SUBJECT: ADDENDUM # 2

PROJECT TITLE: MEP Renovations – Earl Hall
SCSU, New Haven, CT

PROJECT NO.: **BI-RS-248**

BID OPENING	**1:00 P.M.**	**DECEMBER 22, 2009**
ADDENDUM NUMBER ONE	**DATE OF ADDENDUM**	**DECEMBER 14, 2009**

DRAWING NO: SK-M1

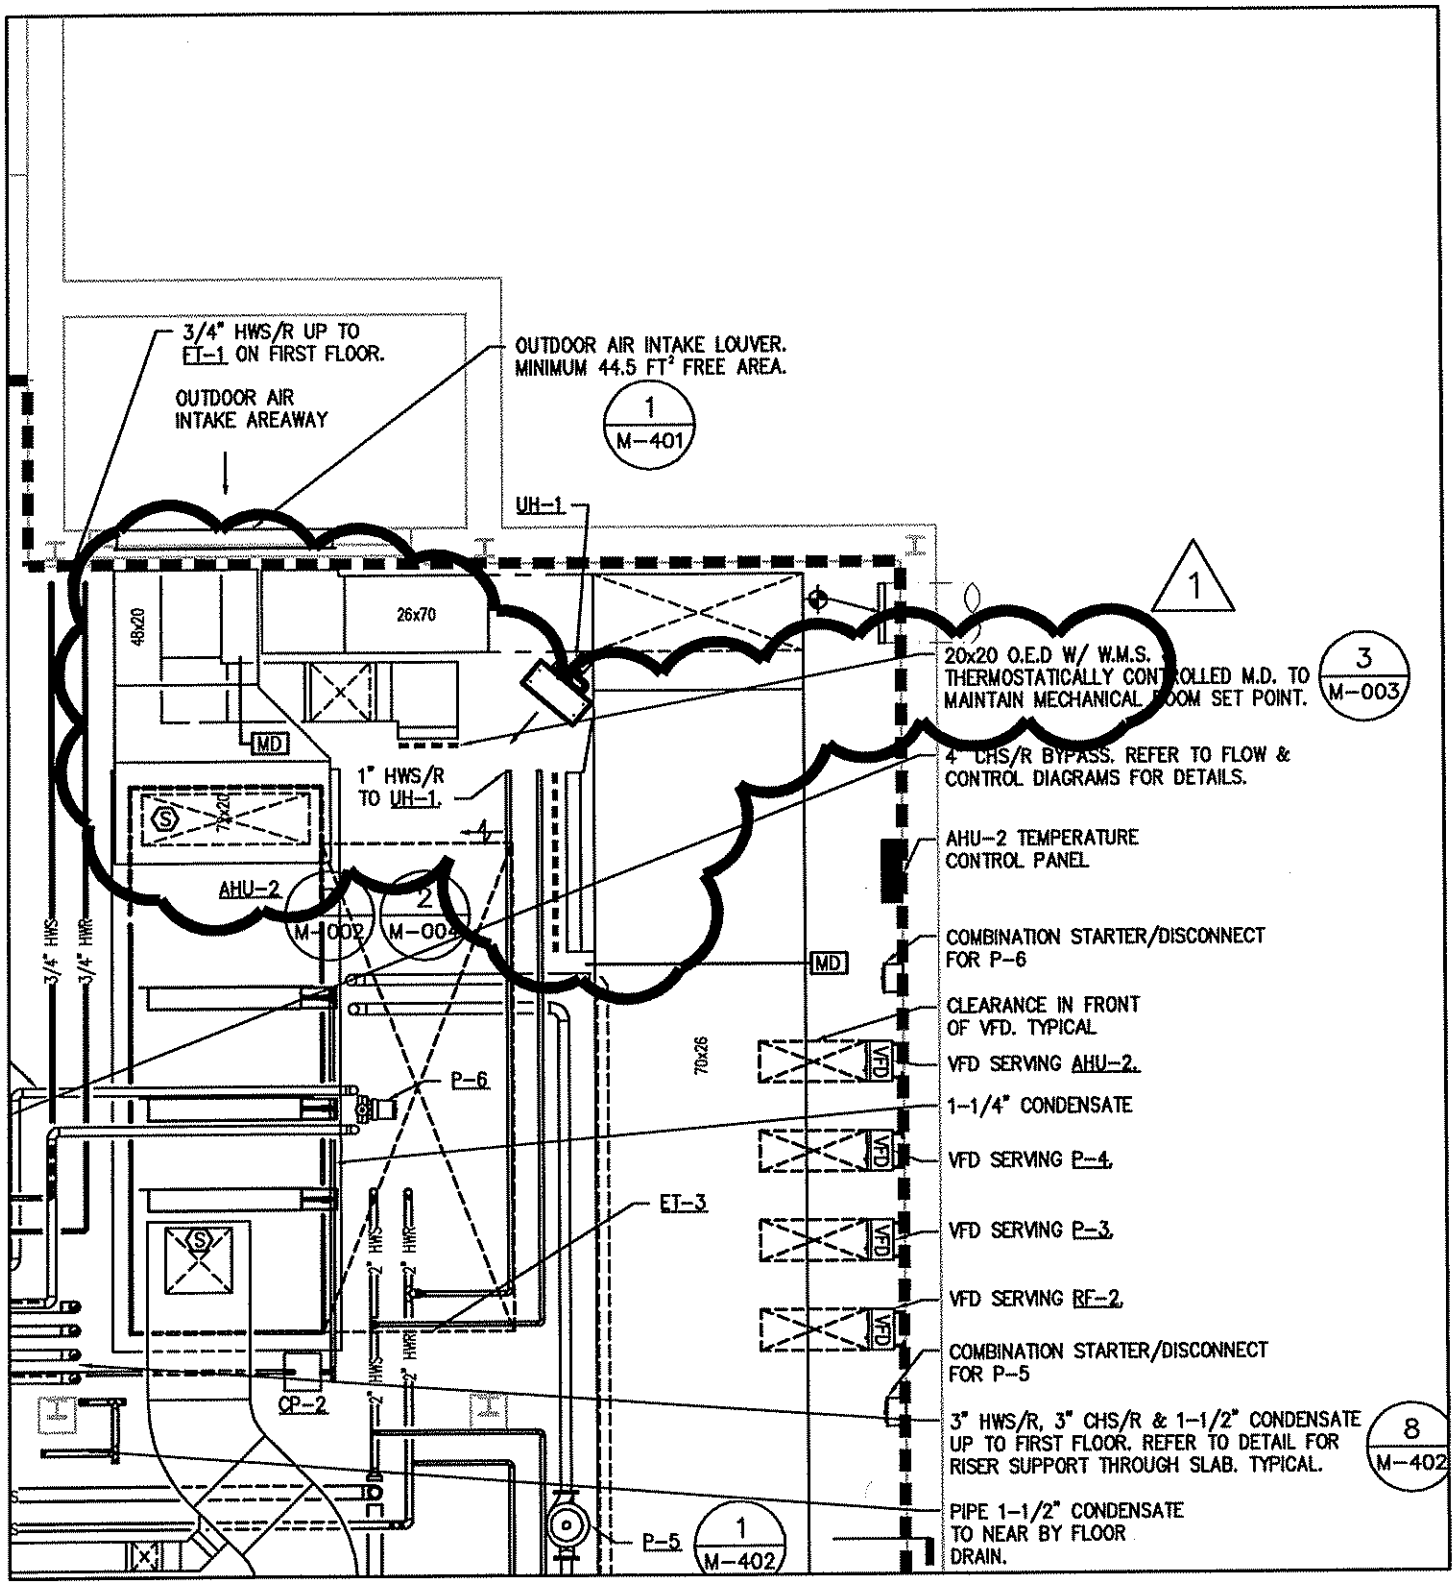
Item 9
DRAWING: M-200

Revised the outdoor air duct connection to the outdoor air intake louver. Refer to mechanical sketch SK-M1.

DRAWING NO:
SK-M2

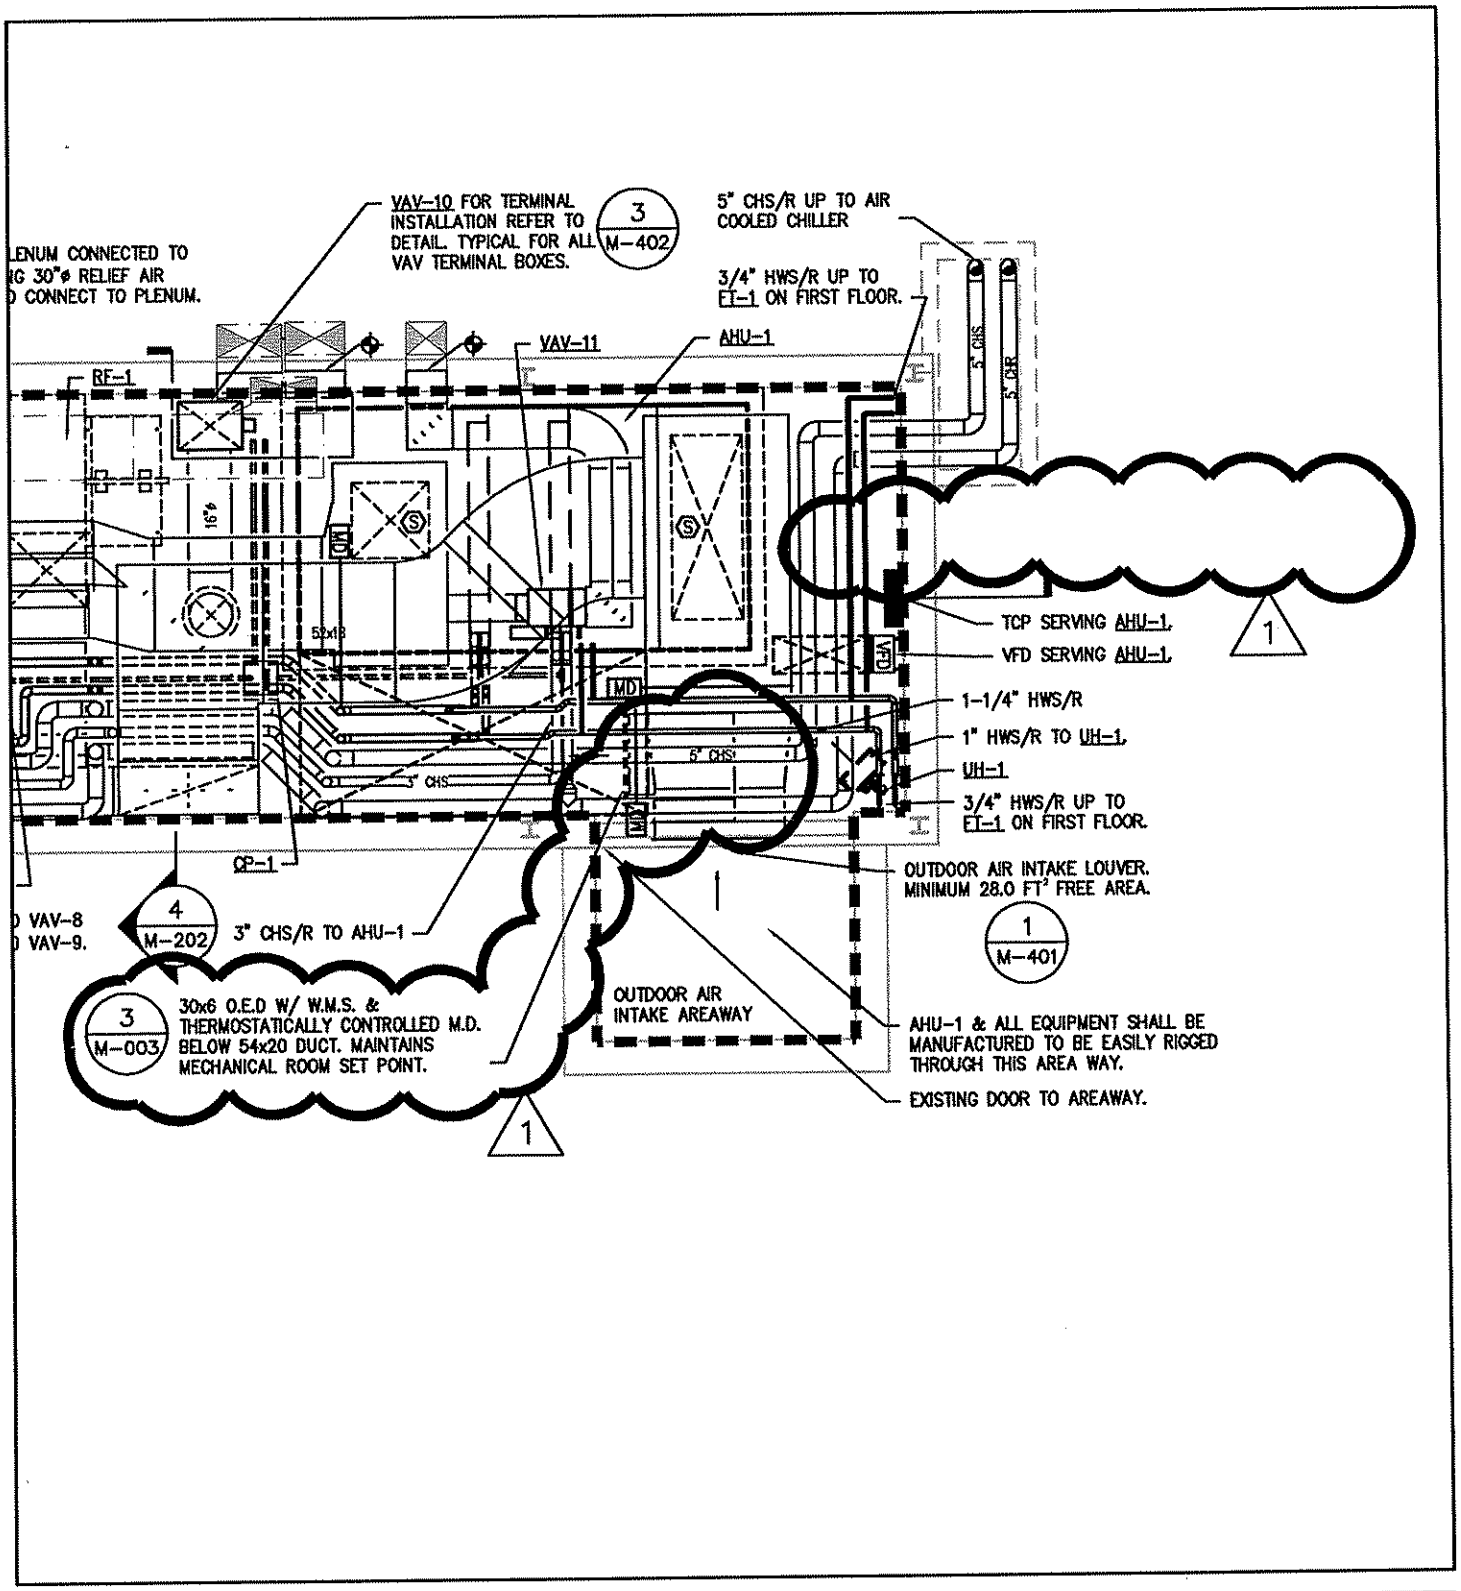
Item 10
DRAWING: M-201

Revised the outdoor air duct connection to the outdoor air intake louver. Refer to mechanical sketch SK-M2.

DRAWING NO:
SKP-1
DATE: 12-11-09
SCALE: NONE

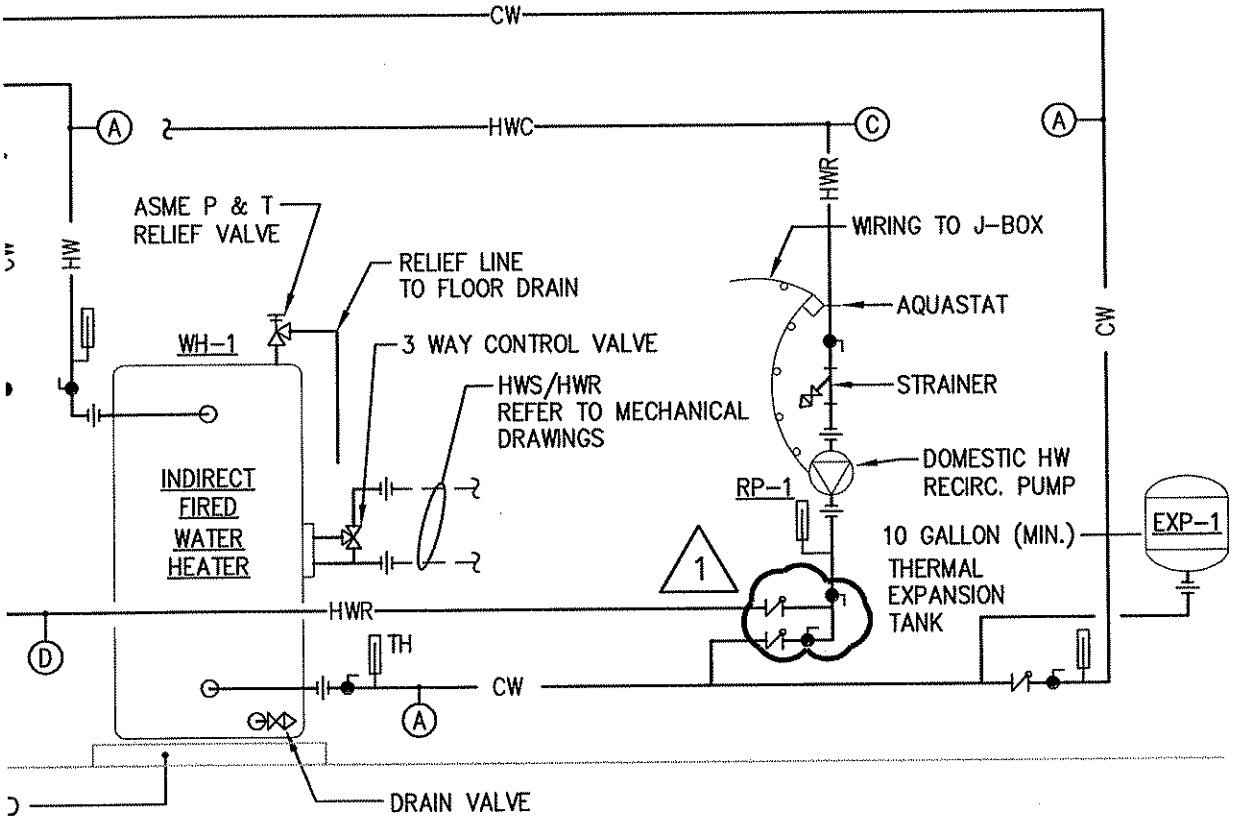
Item 8
DRAWING: P-201 Detail 2: Water Heater Piping Diagram

Revised the detail. Refer to SKP-1.

DRAWING NO:
SK–A1
DATE: 12–10–09
SCALE: AS NOTED

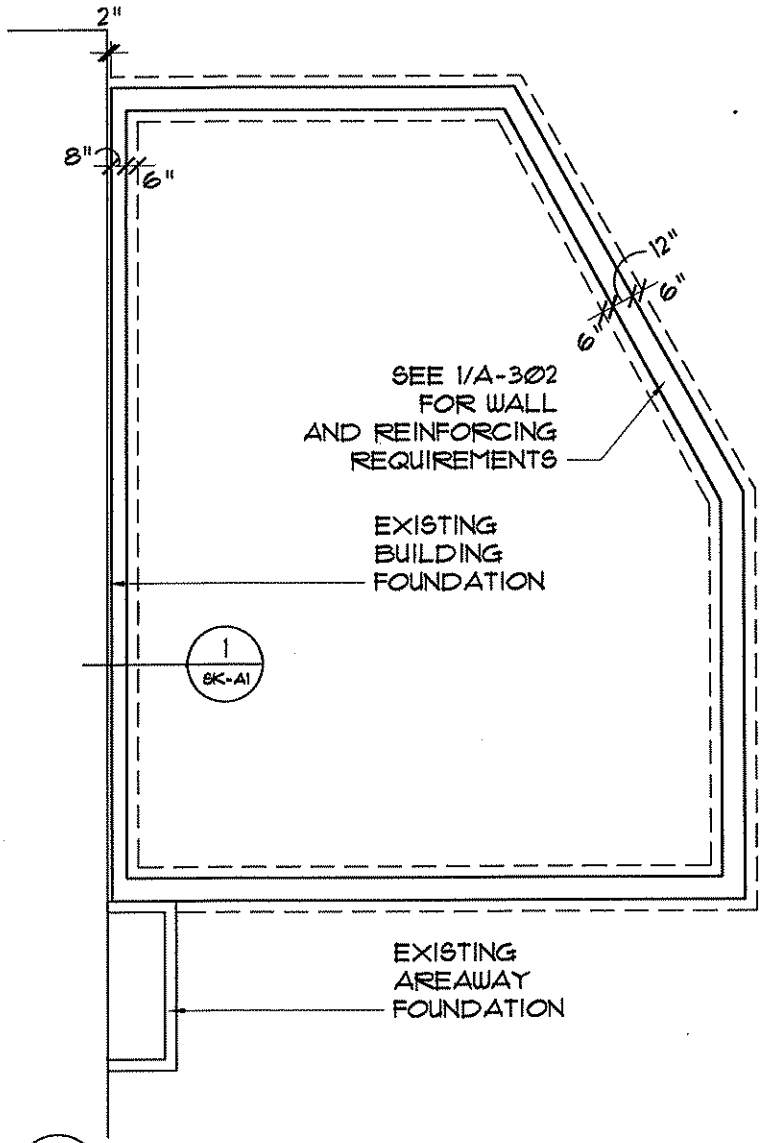
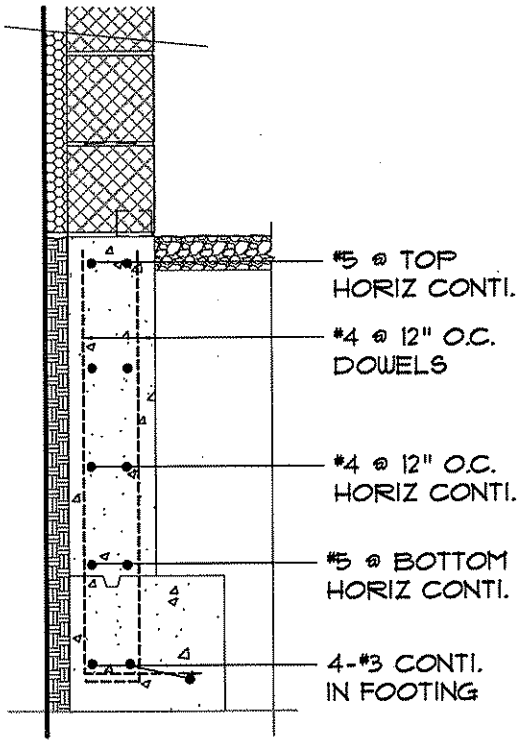
Can you please confirm the foundation requirements at the chiller enclosure as illustrated on 7/a-302 along the existing building. The section only addresses the CMU wall, not the concrete. It doesn't seem likely that a foundation already exists in this area.

ANSWER:
Please see attached SK-A1 for foundation requirements for the chiller enclosure.

DRAWING NO:
SKF-1
DATE: 12-11-09
SCALE: 3/32"=1'-0"

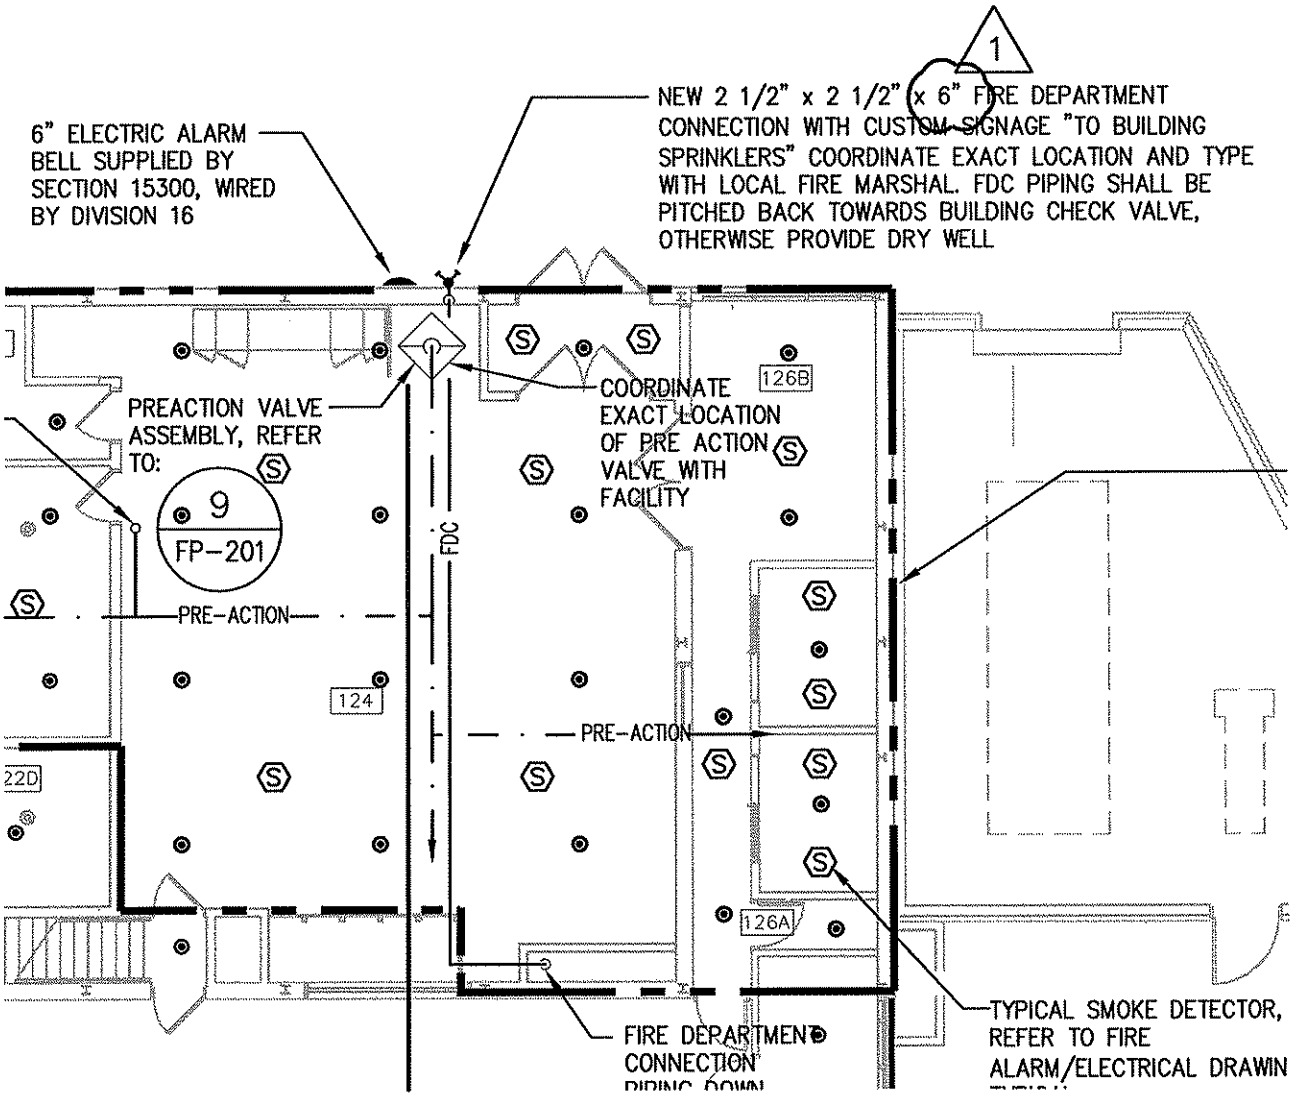
Request: The above referenced drawings show conflicting information for the proposed Fire Department Connection. Sheet 100 specifies 6-inch piping and FDC whereas FP-101 calls for a 4-inch FDC and piping. Please Clarify.

ANSWER:
The fire department connection shall be 6", the drawings shall be revised accordingly. Refer to fire protection sketch SKF-1.
